DCP/NRC1532  
Docket No. 52-006

**“AP1000 Design Certification Review –  
Response to Request for Additional Information”**

# AP1000 DESIGN CERTIFICATION REVIEW

## Response to Request For Additional Information

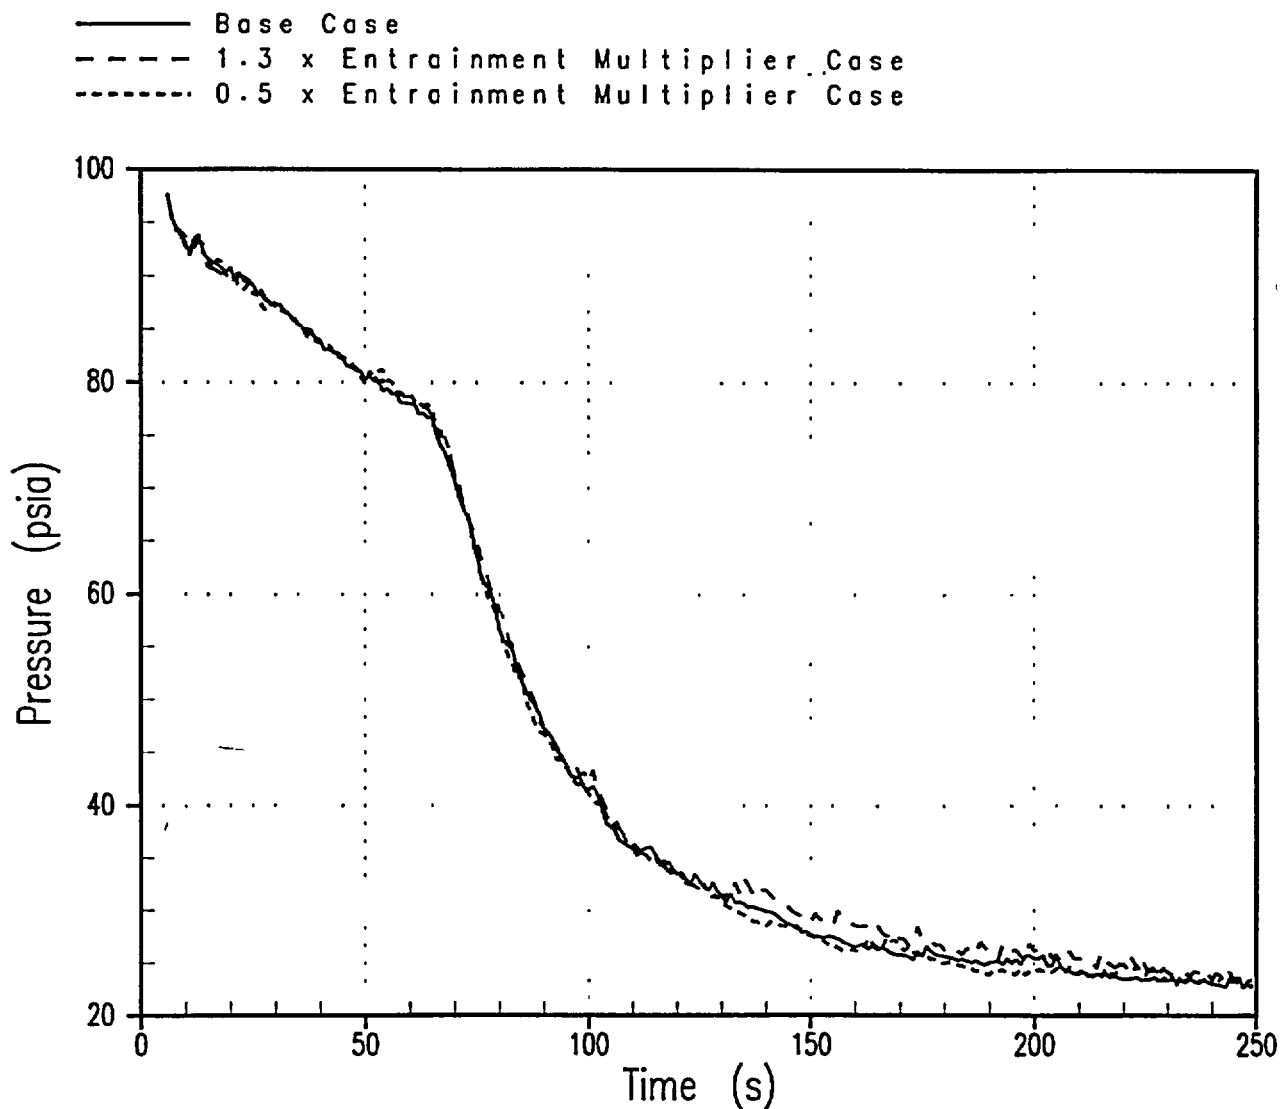
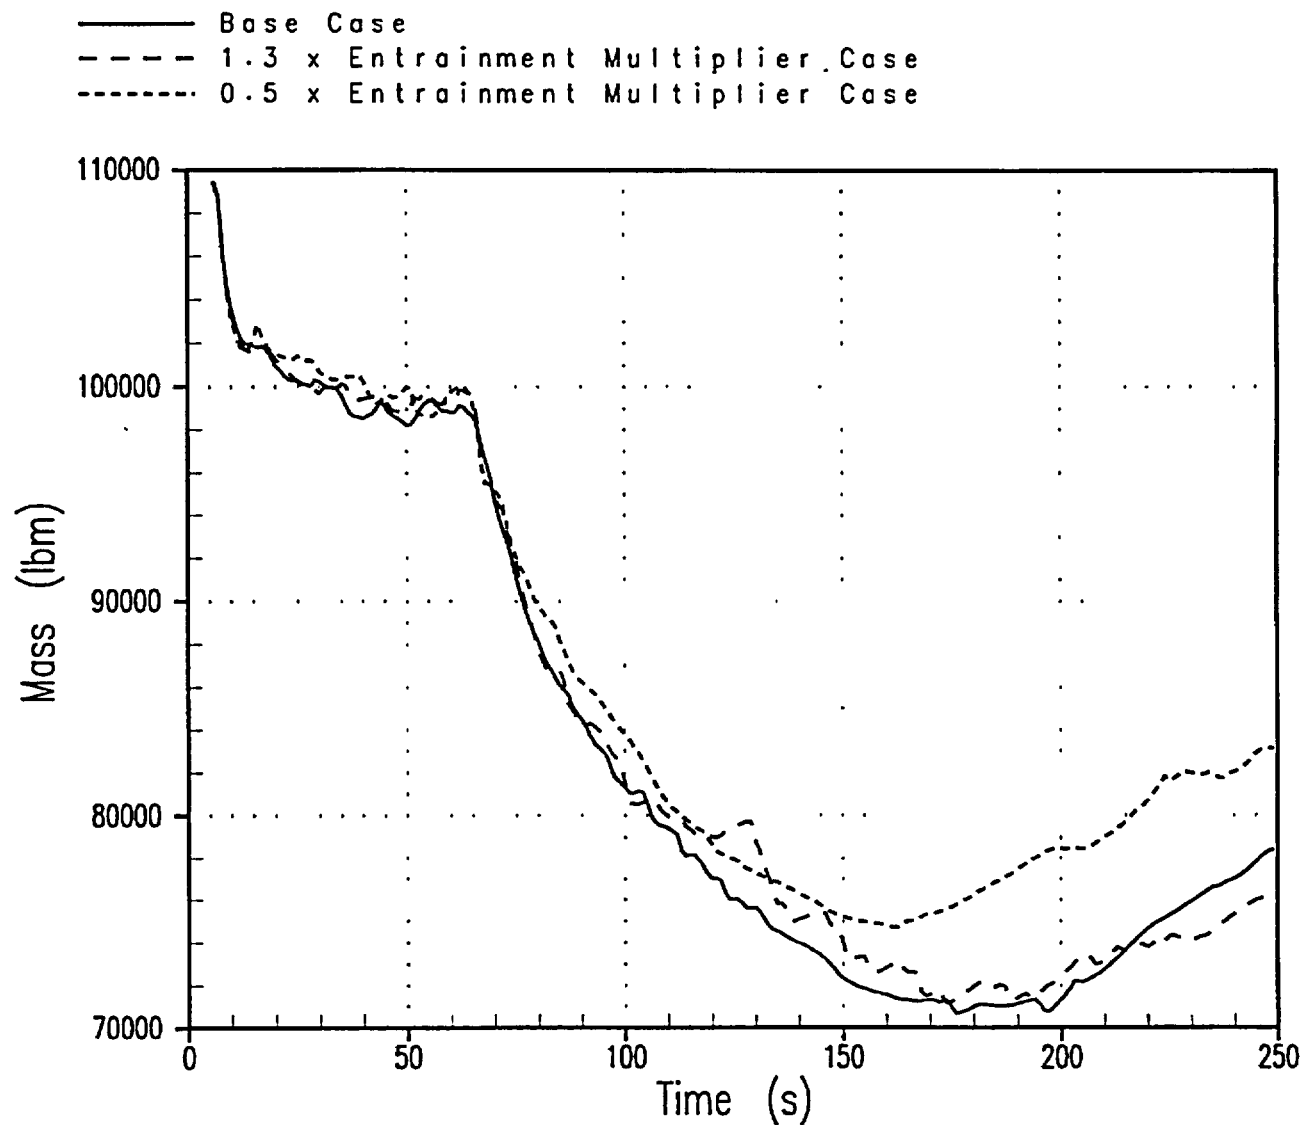
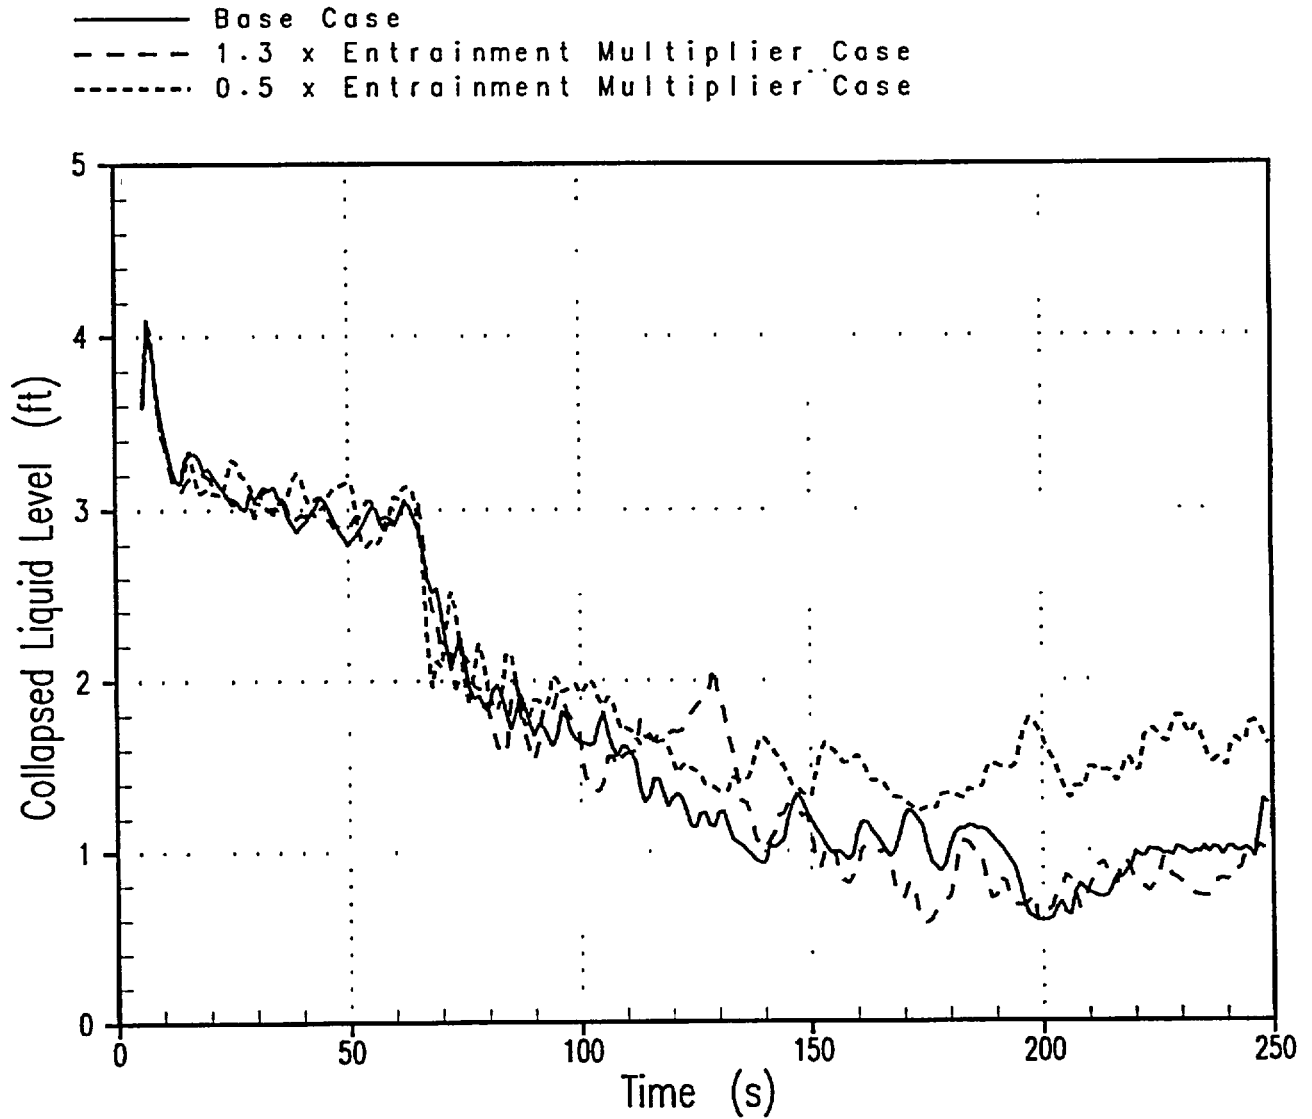
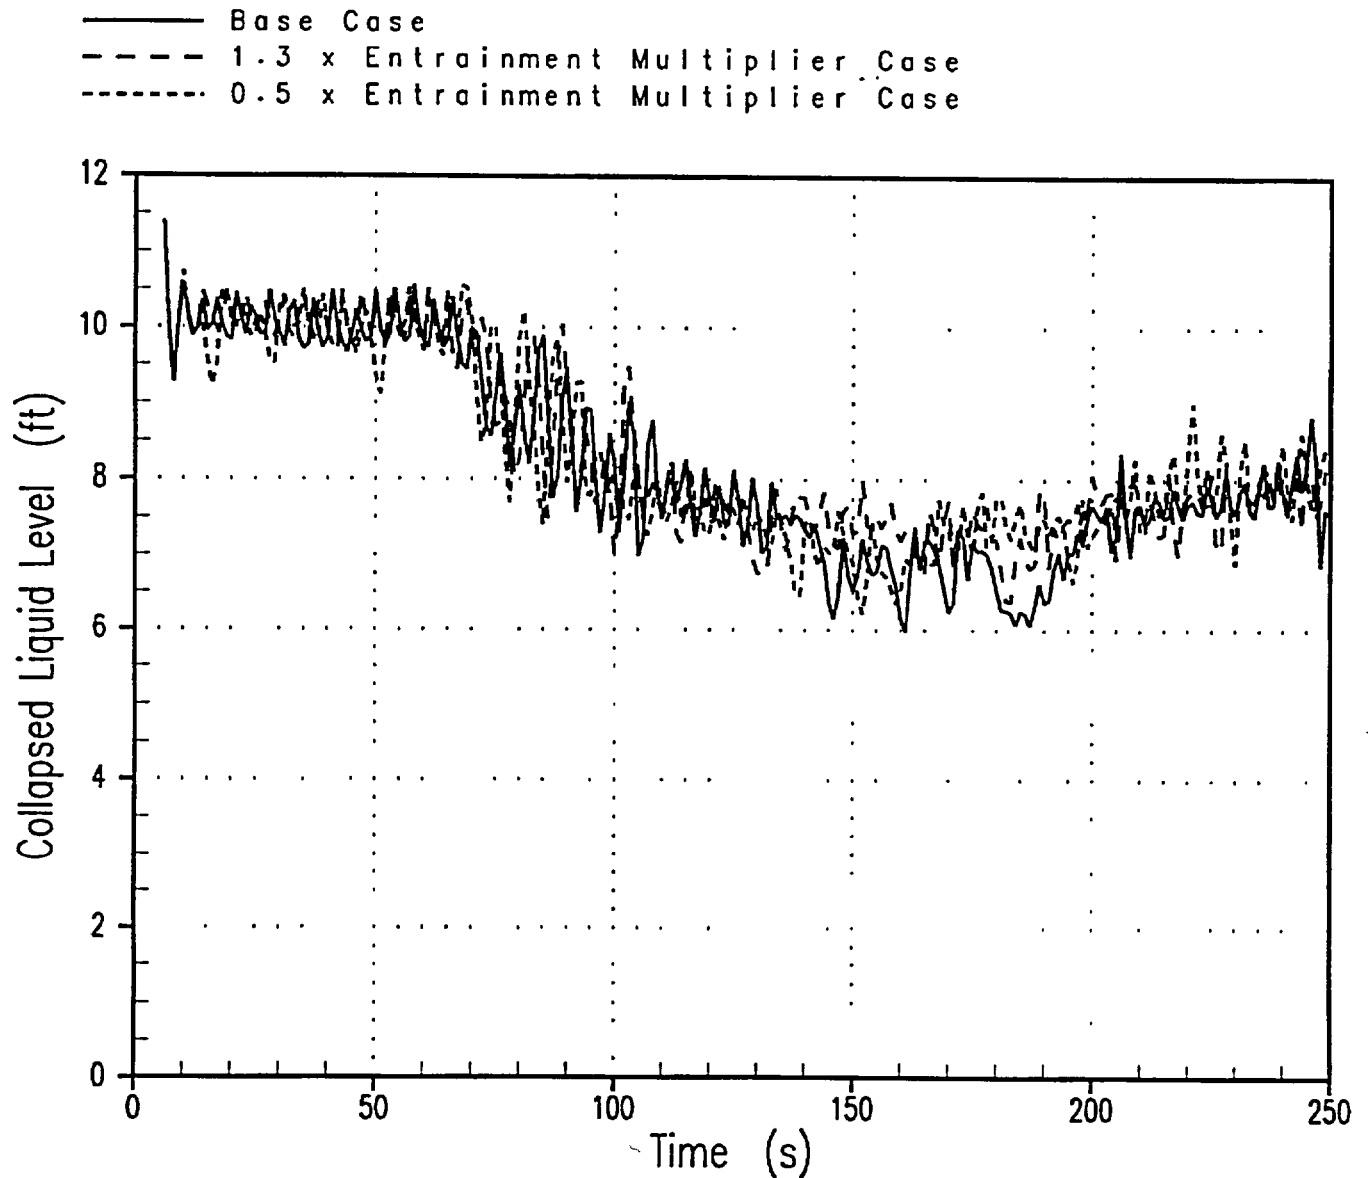
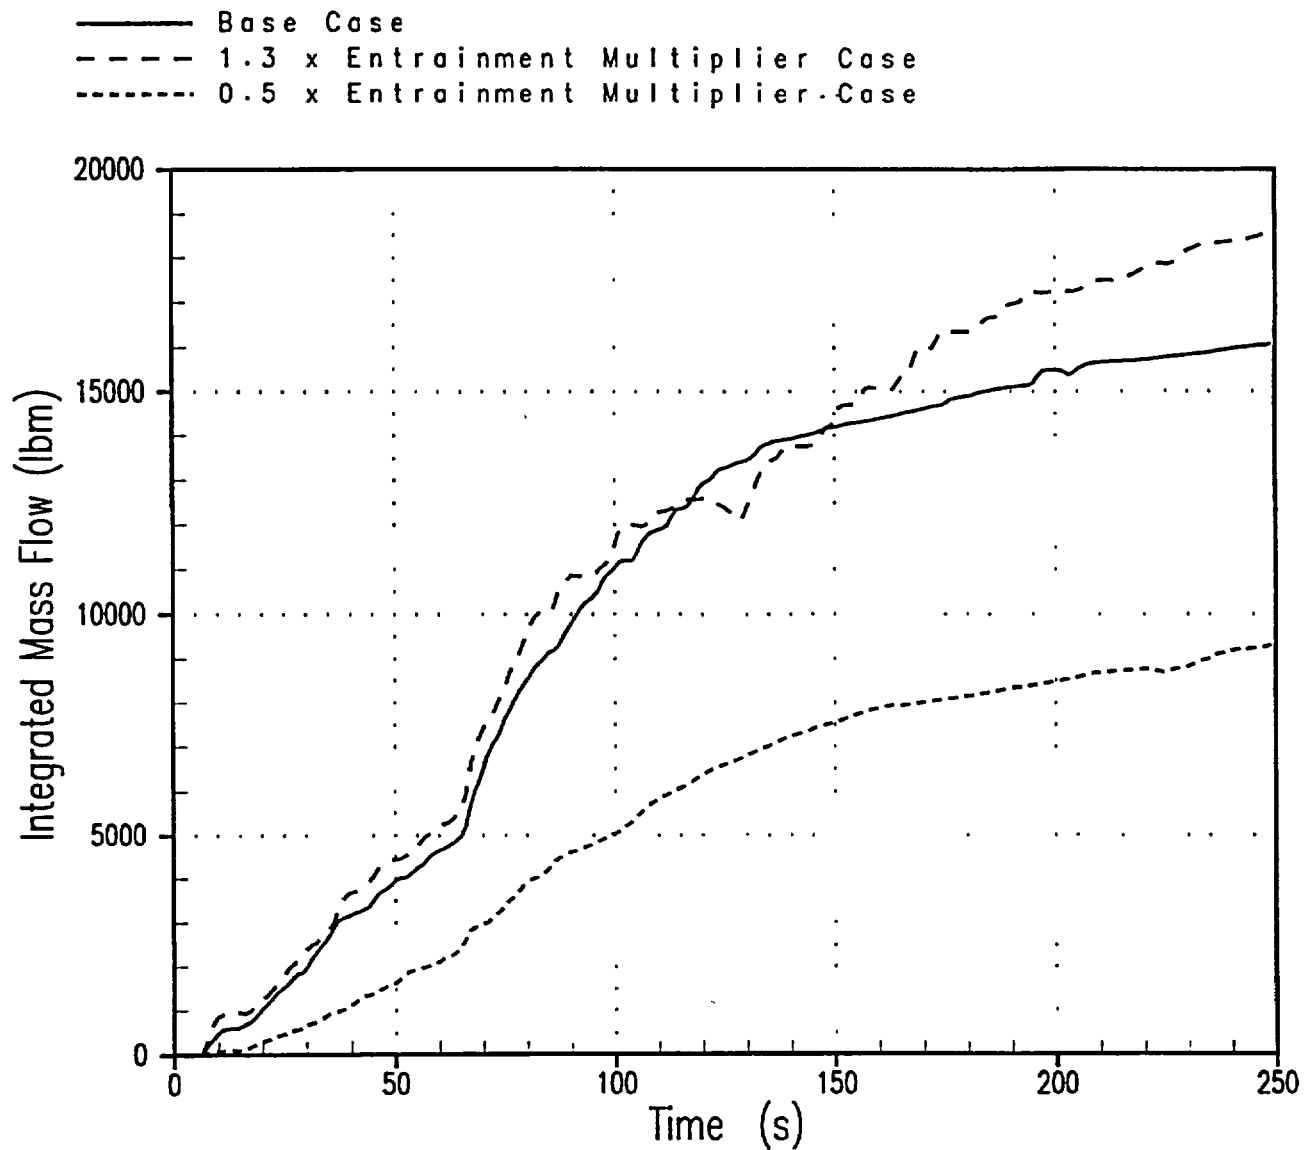
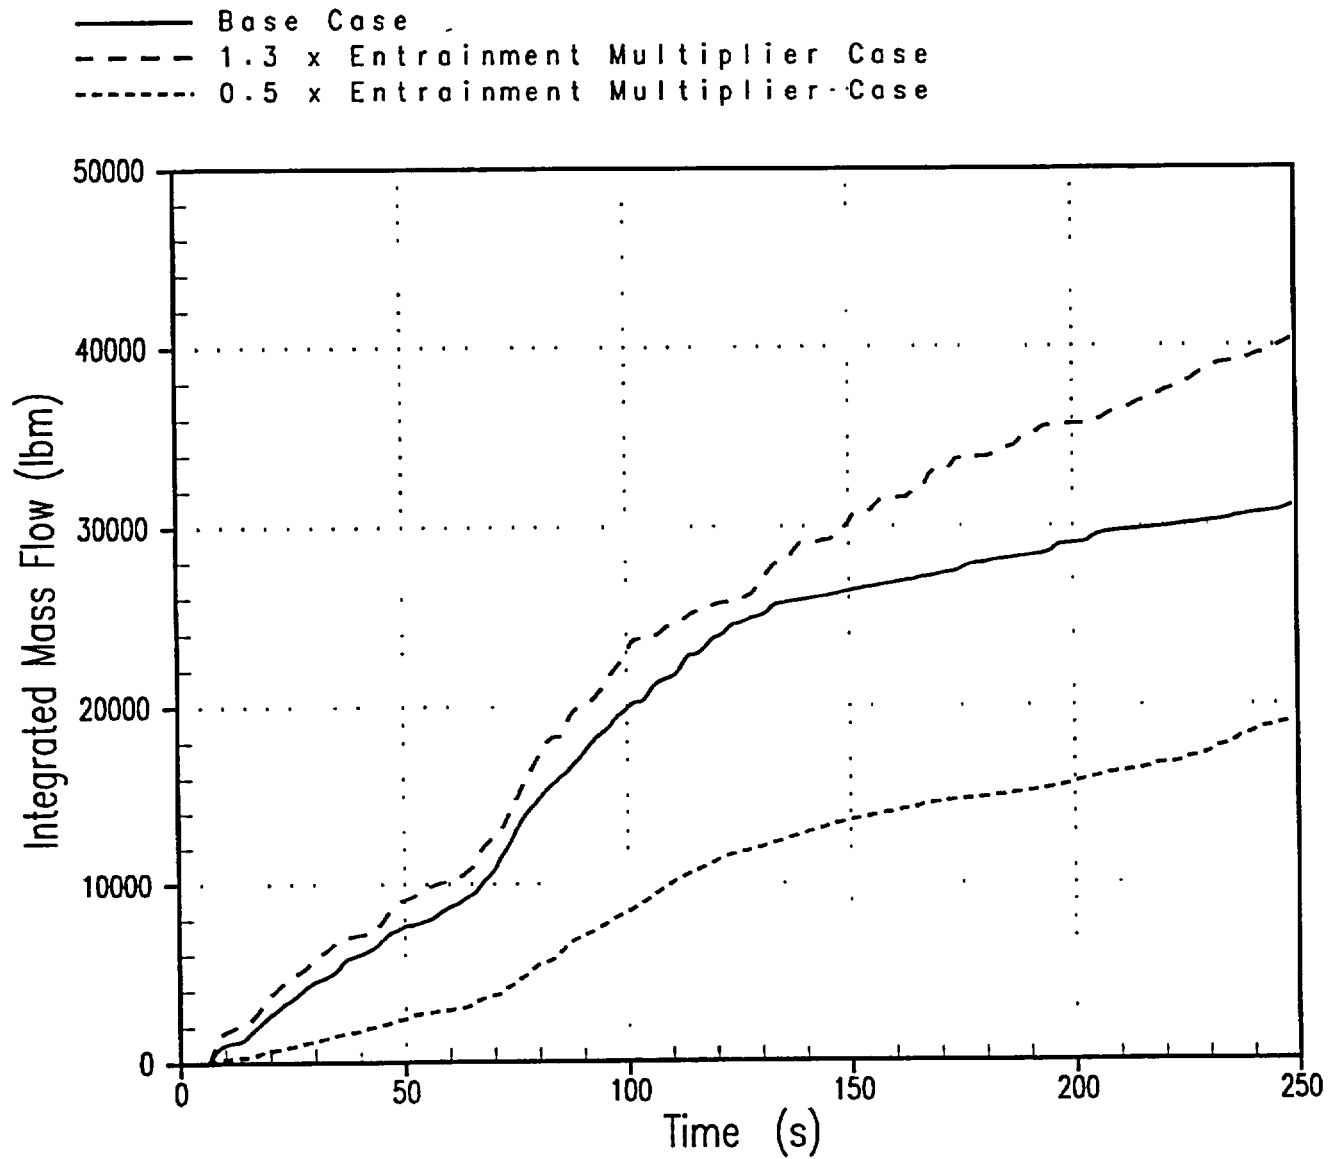
Figures C31 and C33 in Appendix A show that the core mass is underpredicted throughout the simulation, and the upper plenum mass is overpredicted by the code for the first 450 seconds or so. These figures indicate that a bias to overpredict core entrainment appears to exist when the core is quenched as well as unquenched. The requested sensitivity study is to investigate a range of core (and upper plenum) entrainment rates. Taking into account the WCOBRA/TRAC core entrainment overprediction bias, the upper range value of EMULT is selected to be 1.30, and the lower range value is selected to be 0.5 for this study.

The attached figures provide the results of sensitivity cases in which the core and upper plenum entrainment rates are multiplied by 1.3 and 0.5. The following figures may be compared with the sensitivity case(s) presented in Section A4.2:
